SUBJECT: Provides addl justification re Section II, Item BB to NRC  
 B60903 responses to SER comments identified in util 80716  
 ltr. Required FSAR change encl.

October 9, 1986  
(NMP2L 0897)

Re: Nine Mile Point Unit 2  
Docket No. 50-410

FIGURE 9.1-5c

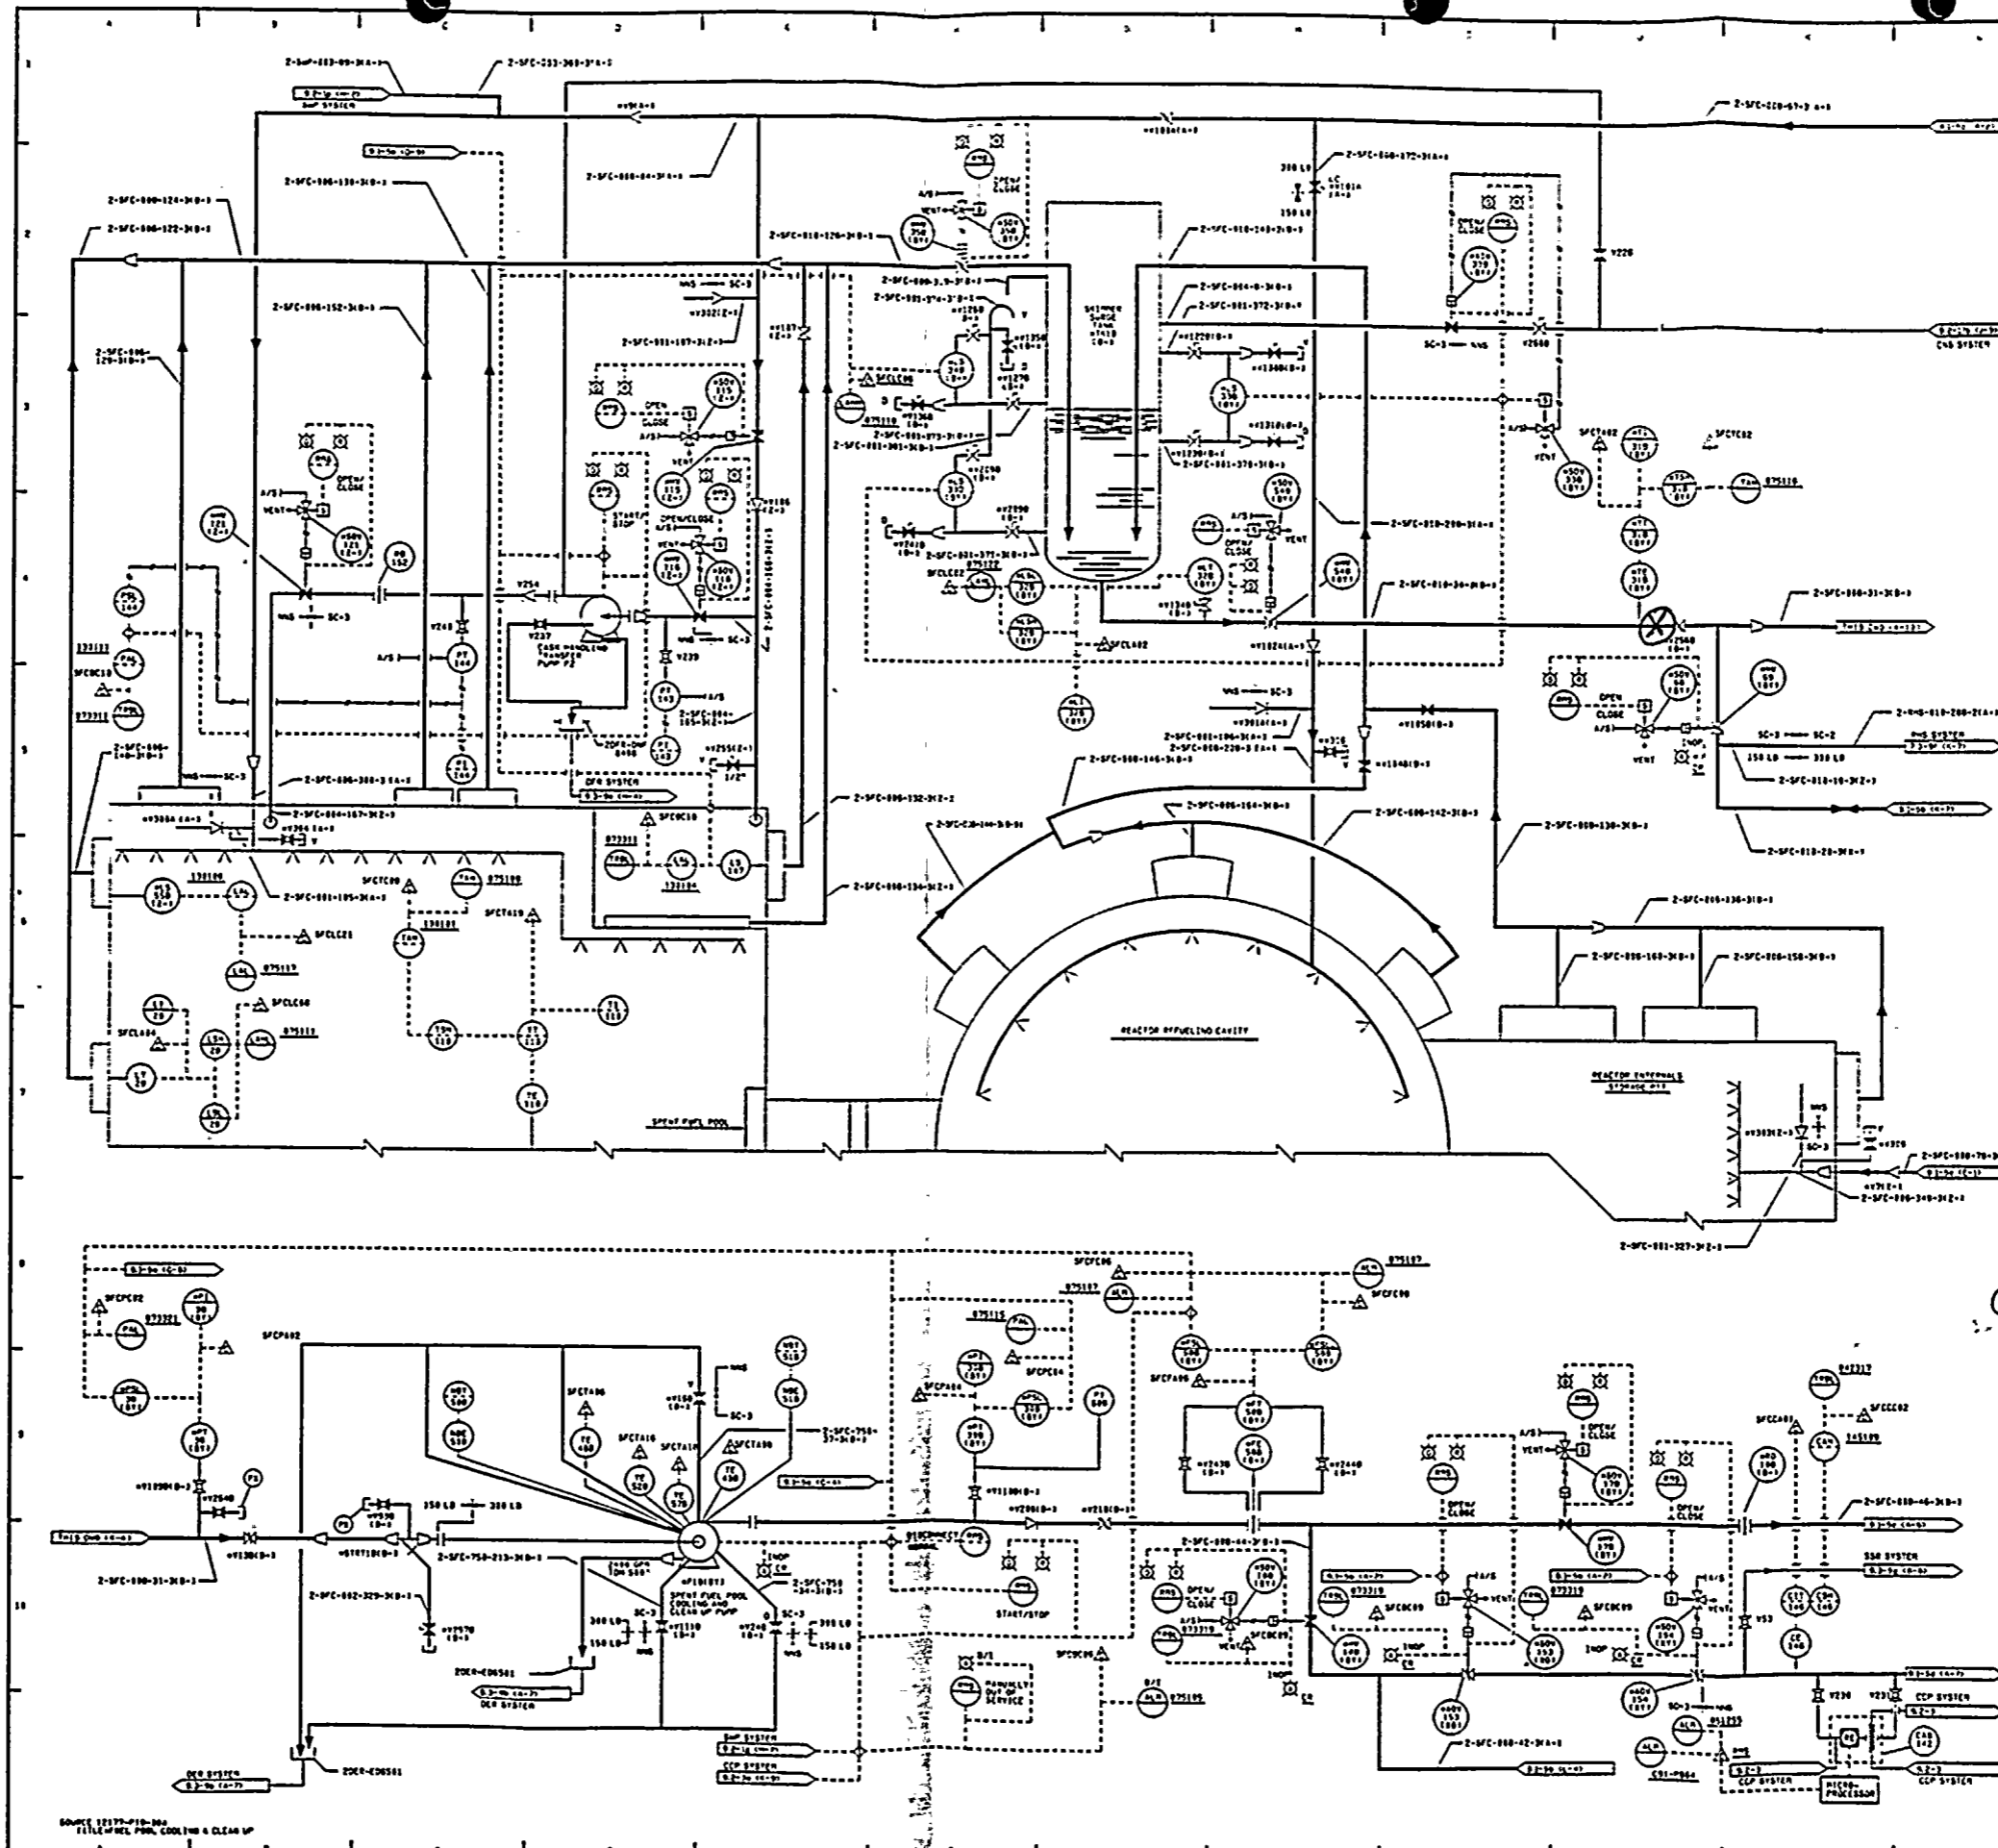
The Amendment 23 FSAR change to 9.1-15 was submitted prior to the completion of the High Energy Line Break (HELB) Analysis. That submittal concluded that at least one loop of the Residual Heat Removal System would be required following a high energy line break. Subsequently, it has been determined that a high energy line break in the spent fuel pool cooling (SFC) area could potentially affect one loop of SFC. However, considering a HELB in the area of one SFC loop and a single failure on the other loop, SFC can still be used to cool the SFC pool. This requires that the Division 1 and Division 2 loops be cross connected. The attached drawings, FSAR Figures 9.1-5a and 9.1-5c, indicate the postulated SFC Targets as a result of the High Energy Line Breaks. This information will not be included in the FSAR and is for information only.
